INSPECTION NOTICE

PROTECTA REBEL SRL

March 13, 2015

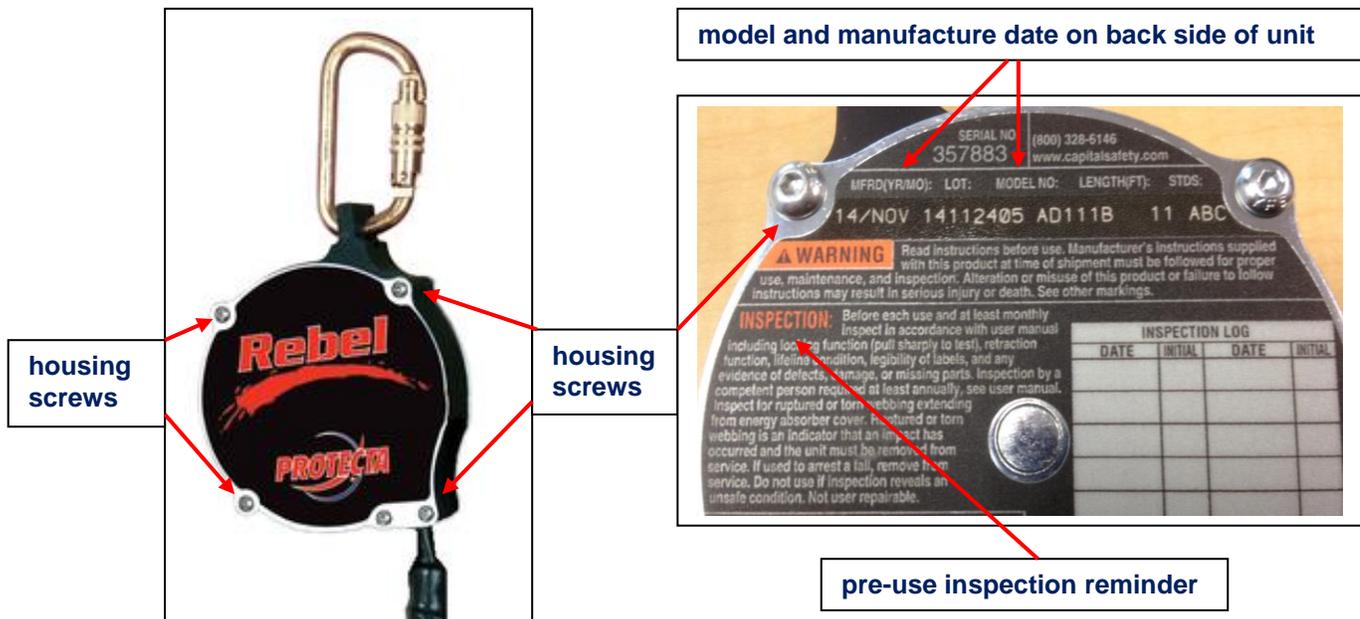
Capital Safety has learned of broken screw heads found in a limited number of Protecta Rebel Self-Retracting Lifelines (SRLs). The units affected by this notice are the black, extruded aluminum housing versions of the Rebel, manufactured between 1 April 2014 and 30 November 2014. (See photograph below.) The affected models are:

Although these units passed final assembly inspection by Capital Safety, reports indicate that the heads of some housing screws have been found broken off by end-users. These units have a total of ten externally visible screws that attach the two exterior housing plates to the main housing (five screws on each side, front and back).

Only the Protecta Rebel SRL models identified above are affected by this notice, and only those units manufactured between 1 April 2014 and 30 November 2014. Although we are confident this issue is limited to a select manufacturing lot of screws supplied by our vendor, we have taken the precaution of changing the type of screws used in these units to eliminate any potential of the condition reported.

- a) remind your workers to conduct pre-use inspections of their Rebel SRLs (as well as their other fall protection equipment);
 - the Rebel pre-use inspection checklist is
 - i. summarized on the product label under “Inspection” (see photograph on previous page), “check for any evidence of missing parts” and
 - ii. set out in full in the Rebel user manual, including the specific requirement to check that “all screws and rivets are present.”
 - missing or broken housing screw heads will be readily visible;
- b) if any housing screw heads are missing or broken, take the unit out of service;
- c) if no housing screw heads are missing or broken, the units are safe to remain in service.

What to do if any Rebel SRL manufactured between 1 April 2014 and 30 November 2014 is found with a broken or missing housing screw head: The SRL should be removed from service and returned via distribution to Capital Safety, or users can call our Customer Service department directly at 1-800-328-6146 to arrange to return their unit.
